Project	28 Lockwood Avenue, Belrose
Report	BCA Assessment Report (BCA 2022)
Reference	C21844-BCA 2022-r1.2
Date	6/03/2024
Client	Autobiography Pty Ltd
Email	Ziad Ali ziad@autobiography.net.au

1. Document Control

FIGURE 28 (in part) HANDRAILS TO STAIRS WITH INTERMEDIATE LANDINGS

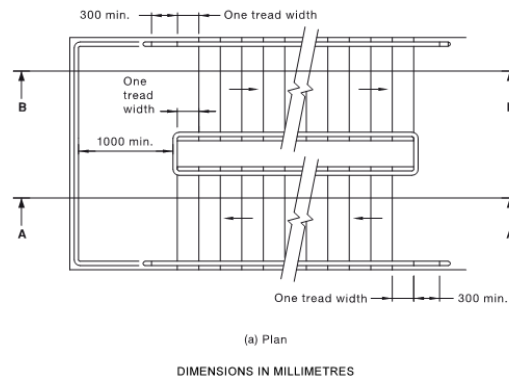
Ensure that the fire-isolated stairways have the stair set backs at the bottom of a stair flight as per Figure 26 of AS1428.1-2009 to ensure that the handrails maintain a consistent height.

FIGURE 26(C) STAIR HANDRAILS—HANDRAIL TERMINATIONS

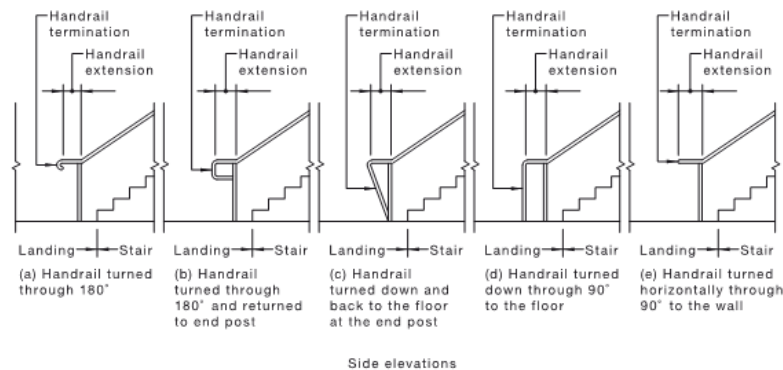
The bottom of the fire-isolated stairways are to be provided with handrail extensions representing one treads length on the angle, plus 300mm horizontally plus a turn down. The one treads length is required to extend straight out from the stairs in line with the direction of the stairs. Please show the handrail extensions.
